UNITED STATES
DEPARTMENT OF THE INTERIOR
BUREAU OF LAND MANAGEMENTFORM APPROVED
OMB NO. 1004-0137
Expires: January 31, 2018**SUNDRY NOTICES AND REPORTS ON WELLS**
Do not use this form for proposals to drill or to re-enter an abandoned well. Use form 3160-3 (APD) for such proposals.5. Lease Serial No.
NMNM128360

☐ Oil Well ☒ Gas Well ☐ Other8. Well Name and No. **316248**
ARMSTRONG 26 23 W1ED FED COM 2H2. Name of Operator
MEWBOURNE OIL COMPANYContact: JACKIE LATHAN
E-Mail: jlathan@mewbourne.com9. API Well No.
30-015-43798-00-X13a. Address
P O BOX 5270
HOBBS, NM 882413b. Phone No. (include area code)
Ph: 575-393-590510. Field and Pool or Exploratory Area
ROSS RANCH

Mewbourne Oil Company has an approved APD for the above well. Mewbourne requests approval to make the following changes:

Mewbourne Oil Company, Armstrong 26/35 W1LM Fed Com #2H

WELL LOCATION AND ACREAGE DEDICATION PLAT

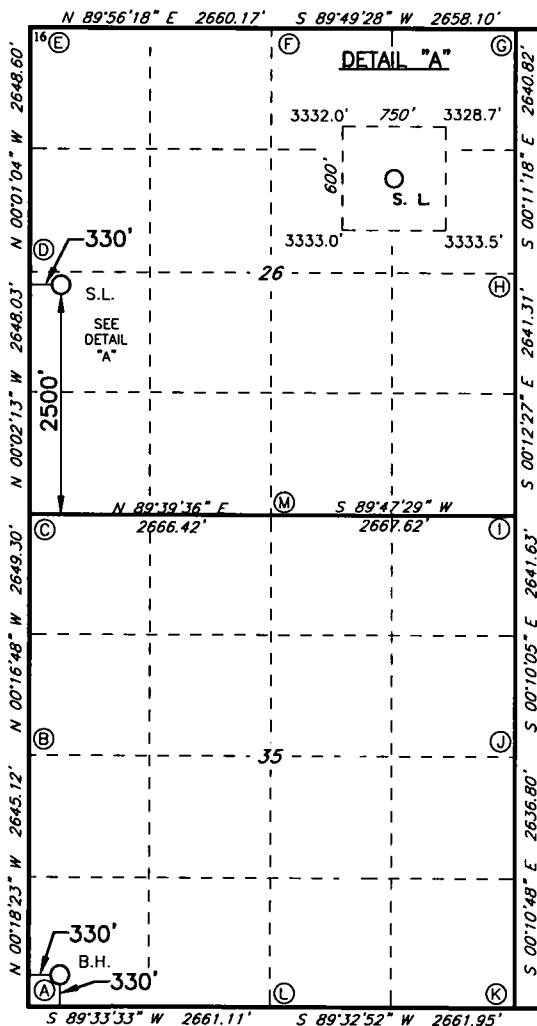
- 1) Change well name to Armstrong 26/35 W1LM Fed Com #2H.
- 2) Change pool to 98226.
- 3) Change BHL to 330' FSL & 330' FWL, Sec 35.
- 4) Change csg depth and cement to suit new plan.
- 5) Change wellhead to multi-bowl type wellhead.
- 6) Change BOP and request variance to use 5M annular with a 10M BOP stack.
- 7) Change spacing to 240 acres.

10M BOPE & Closed Loop Equipment Schematic

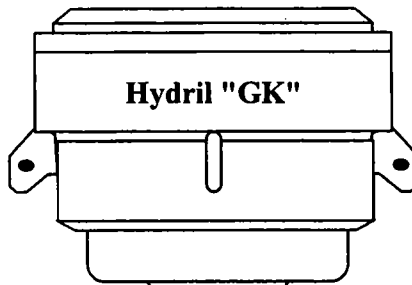
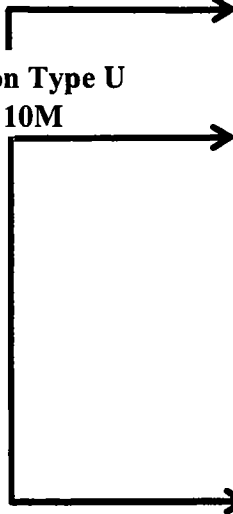
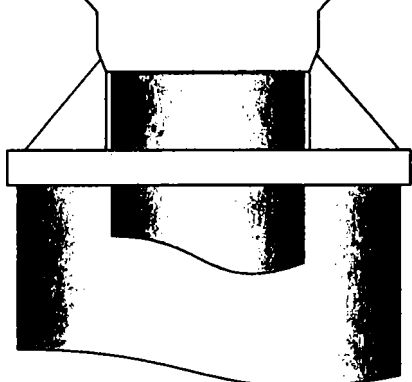
Variance: A variance is requested to use a 5000 psi annular with a 10000 psi BOP stack. See attachment for description.
--	---

10,000 PSI Annular BOP Variance Request

Mewbourne Oil Company request a variance to use a 5000 psi annular BOP with a 10,000 psi BOP stack. The component and compatibility tables along with the general well control plans demonstrate how the 5000 psi annular BOP will be protected from pressures that exceed its rated working pressure (RWP). The pressure at which the control of the wellbore is transferred from the annular preventer to another available preventer will not exceed 3500 psi (70% of the RWP of the 5000 psi annular BOP).

1. Variance approved to use flex line from BOP to choke manifold. Manufacturer's specification to be readily available. No external damage to flex line. Flex line to be installed as straight as possible (no hard bends).
2. Minimum working pressure of the blowout preventer (BOP) and related equipment (BOPE) required for drilling below the surface casing shoe shall be **10,000 (10M) psi.**
Variance approved to use a 5M annular. The annular must be tested to full working pressure (5000 psi.)
